APPLICATION FOR RESOURCE CONSENT OR FAST-TRACK RESOURCE CONSENT

Prepared for: Matthew Paraha
By: Andrew McPhee | Consultant Planner
Reviewed: Steven Sanson | Consultant Planner
Date: 1 July 2024

1. Changes to Condition 1 in relation to the approved plans by Relocate.
2. Changes to Condition 5 in relation to the requirement to upgrade the vehicle crossing with Mangakahia Road to a New Zealand Transport Agency.

3.3 Proposed Change of Consent Conditions

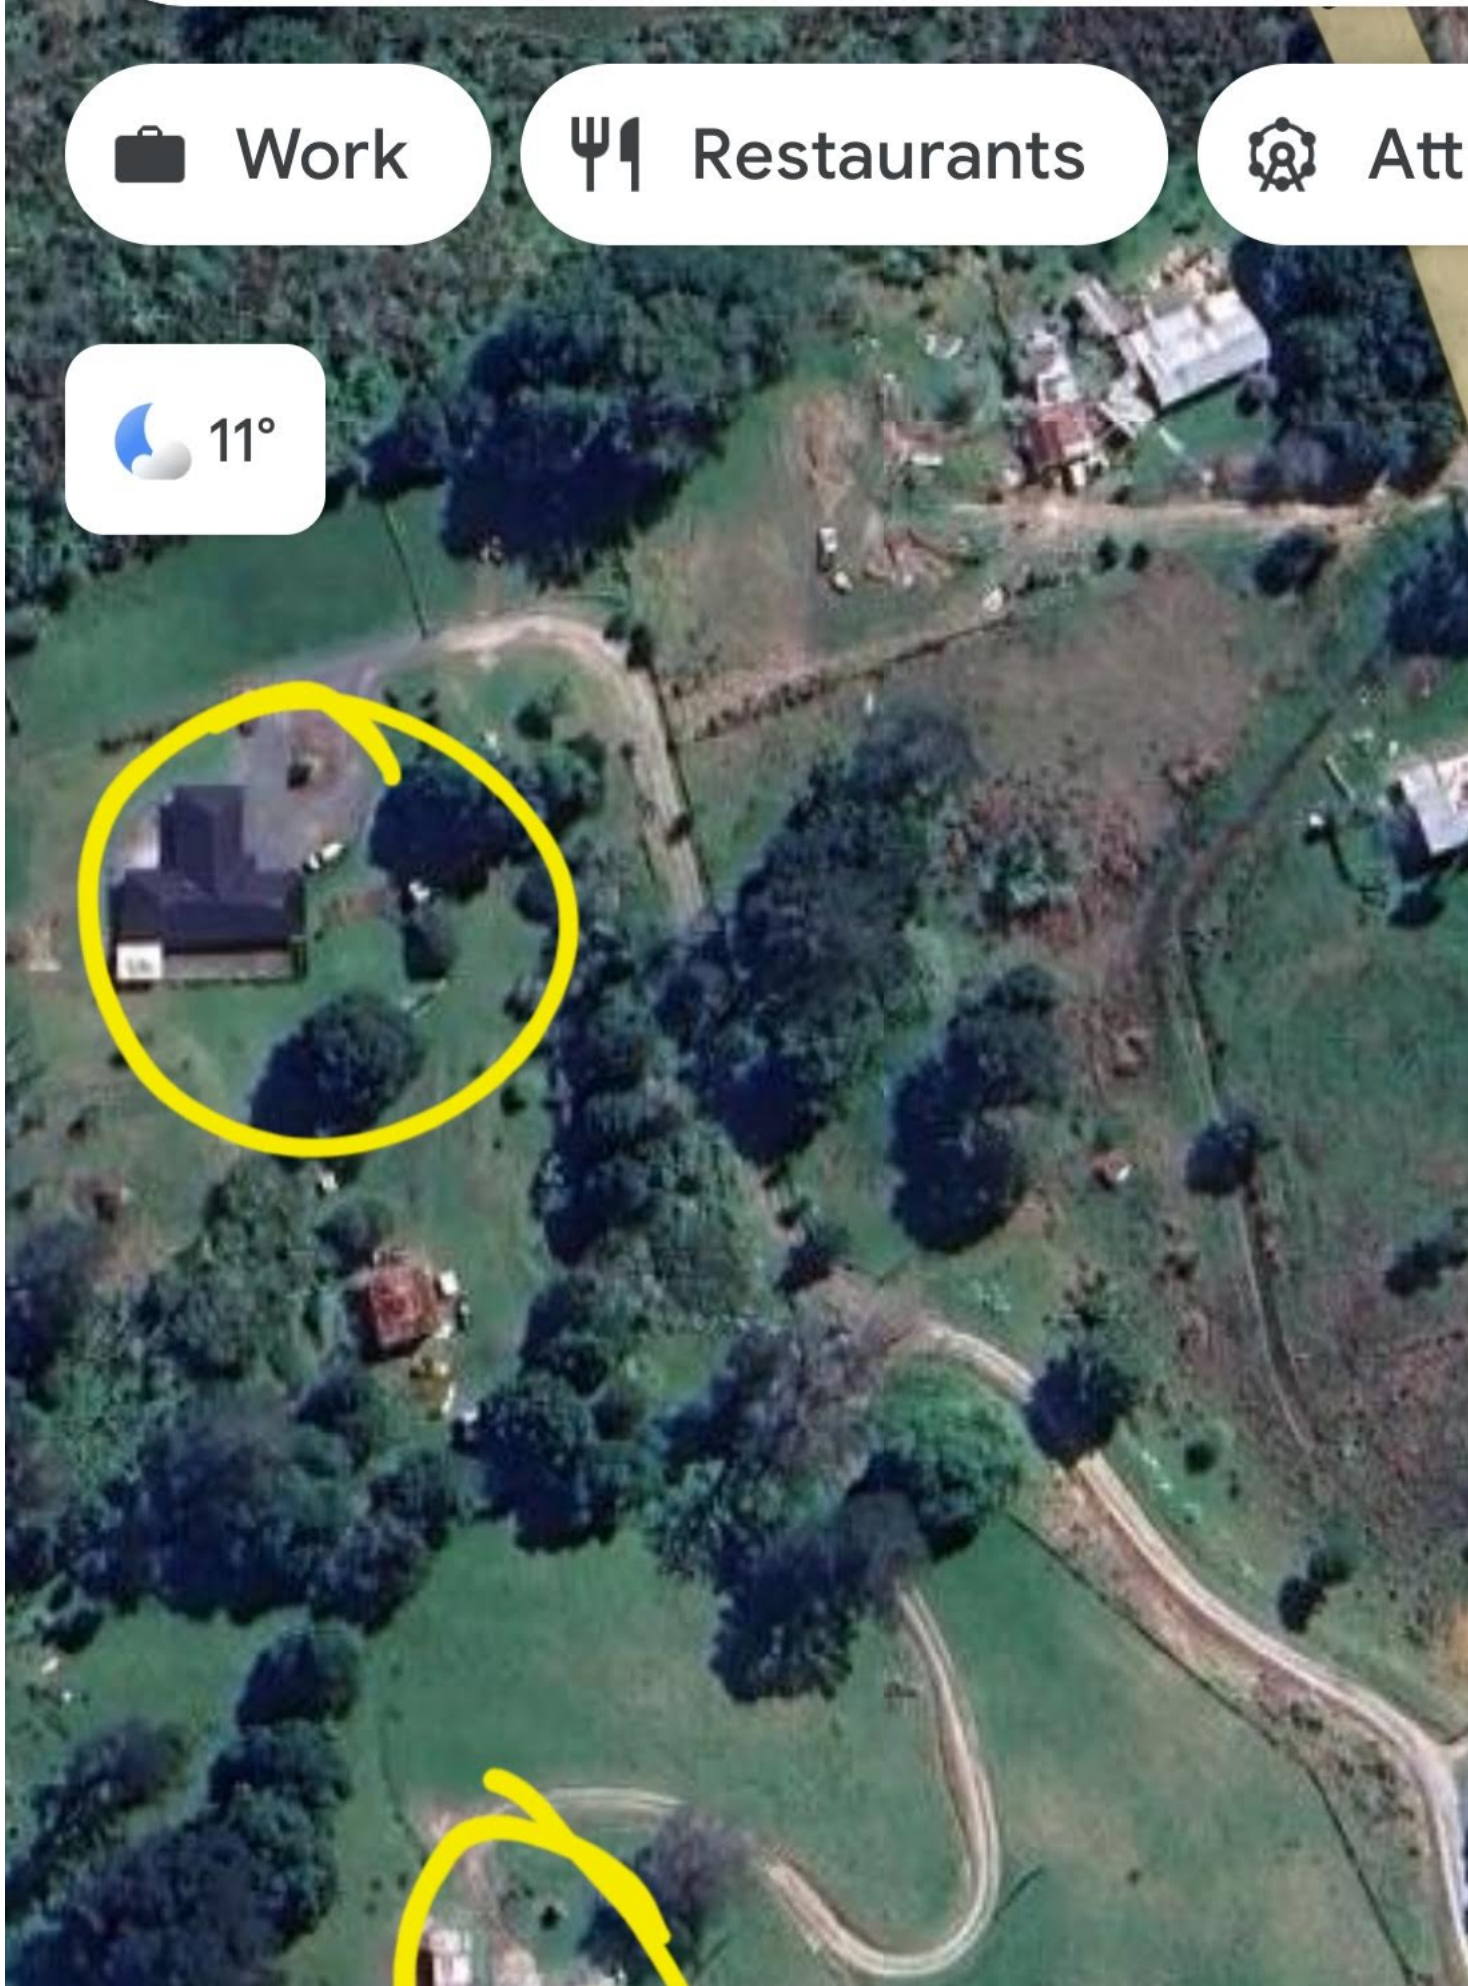
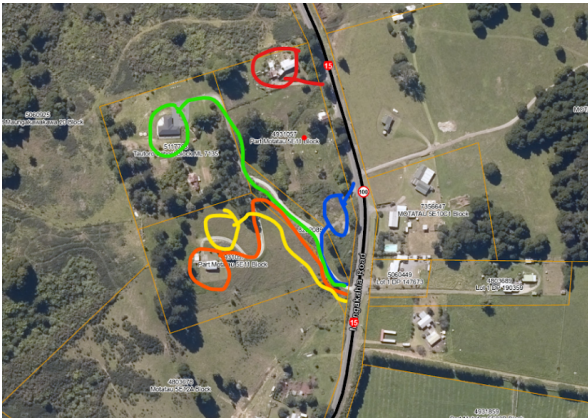
As previously raised, the issue is that the volume of vehicle movements being generated to your crossing place warrants the requirement for a Diagram D upgrade. You (or your agent below) has access to two accesses. If we can move them to just using their own existing access, then our safety engineer is happy to revisit the vehicle movements per day.

Image below from our latest network video shows that current standard of the direct access into the property highlighted in blue in the planning memo – it appears to be for a standard.

Something else to consider is the limited sight lines to the north because of the curve. While we appreciate the reduction in the speed limit to 80km/h is imminent this does PPM, one needs to be achieving around 200m (based on the 80km/h) but as far as we can determine it looks like there is only 100m being achieved.

In conclusion, the information provided recently is not sufficient in changing NZTA position of the access treatment in order to mitigate safety risks. The location which has reduce the VMPD to the subject crossing by removing blue house's access (and showing evidence of this) then this could potentially be a solution. It may also mean that Diagram C. In addition, you mentioned being able to provide a speed test. This may assist if it is shown the operative speed is lower than 80km/h. This being said, I am unsure of the outcome at this stage.
